## **REDLANDS SUBDIVISION, PHASE 2**

APPLICATION NUMBER 6 DATE April 19, 2018

REQUEST Subdivision

# DETAIL SITE PLAN

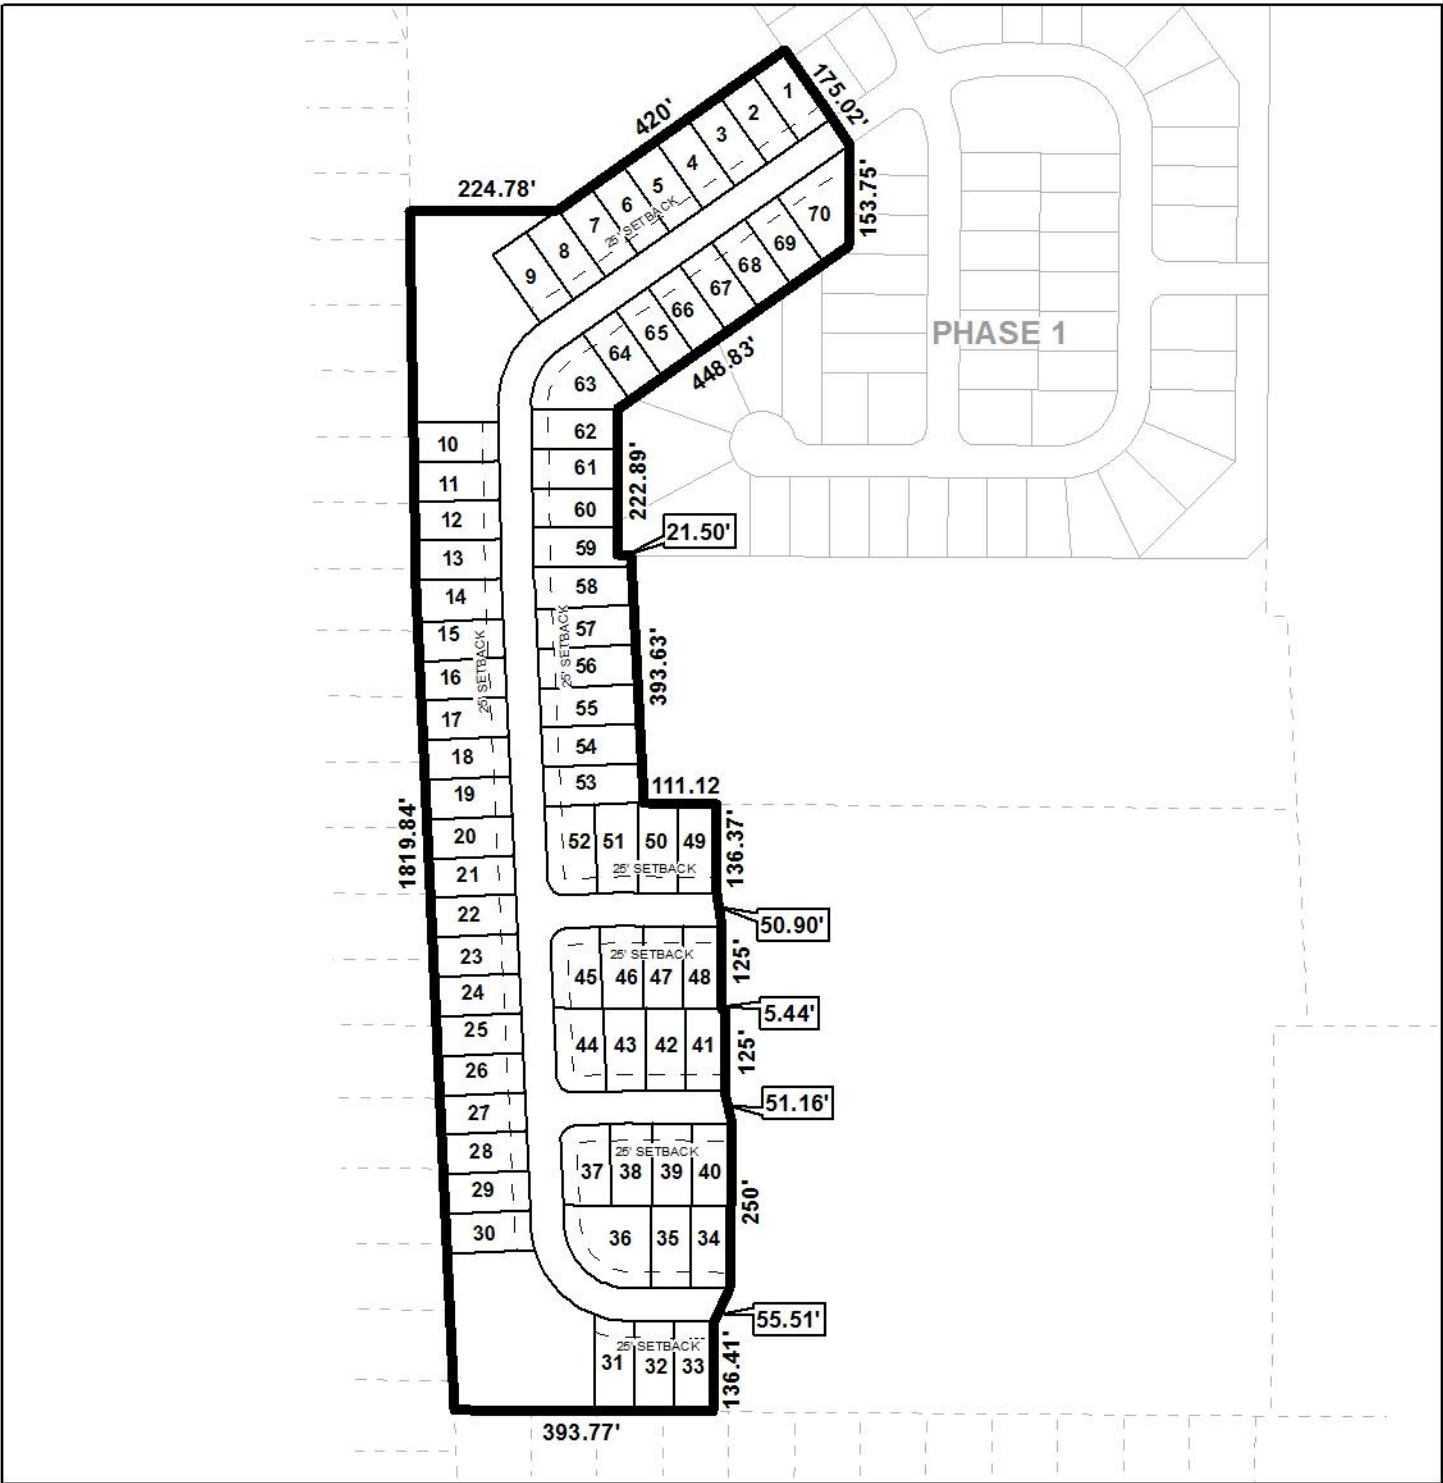
The plat illustrates the proposed 70 lot, 18.5 ± acre subdivision which is located adjacent to East side of Hunters Ridge West Subdivision, Unit 1, and the North side of Hunters Ridge Subdivision, 4<sup>th</sup> Unit, extending to the West side of proposed Redlands Subdivision, Phase 1, and is located within the Planning Jurisdiction. The applicant states that the subdivision is served by public water and sanitary sewer (South Alabama Utilities).

The purpose of this application is to create 70 legal lots of record from a portion of a lot proposed by the Alabama Pecan Subdivision, Phase 1, that was scheduled for the March 15<sup>th</sup> Planning Commission meeting. The application at hand would represent phase two of the Redlands Subdivision; the first phase was also scheduled for the March 15<sup>th</sup> planning Commission Planning meeting. Both Alabama Pecan Subdivision, Phase 1, and Redlands Subdivision, Phase 1, were heldover from the March 15<sup>th</sup> meeting to the April 5<sup>th</sup> meeting due to the lack of a quorum, however, both were recommended for holdover to the April 19<sup>th</sup> meeting due to concerns relating to the proposed extension of Eliza Jordan Road along the western banking of the overall site, as part of the Major Street Plan component of the Comprehensive Plan. Phase 1 of the Redlands Subdivision was additionally recommended for Holdover due to a lack of an overall plan for the entirety of the Redlands Subdivision, depicting all proposed phases. As no overall composite plan showing all proposed phases has been provided for the proposed Redlands Subdivision, staff has no information regarding the total number of phases, the ultimate number of proposed lots, nor the total number of access points for the subdivision.

Based on the preceding, the application is recommended for Holdover to the May 3<sup>rd</sup> meeting so that the following can be addressed:

- 1) an overall plan for the Redlands Subdivision, depicting all proposed phases, lots, and access points to be submitted by April 16<sup>th</sup> ; and
- 2) revision of the proposed subdivision to accommodate the proposed Eliza Jordan Road major street extension.

*The application was heldover from the April 5th meeting to allow staff to research which of the other subdivisions along the proposed Eliza Jordan Road major street corridor were required to accommodate the proposed major street. The applicant was also required to submit an overall conceptual plan depicting all the phases of the development; however staff did not receive a revised plan reflecting that information.*

- 1) A determination must be made on the Alabama Pecan Subdivision request and the associated major street issue prior to the consideration of Phase II, of Redlands Subdivision;*
- 2) No overall conceptual plan depicting all proposed phases of development was provided, as requested.*
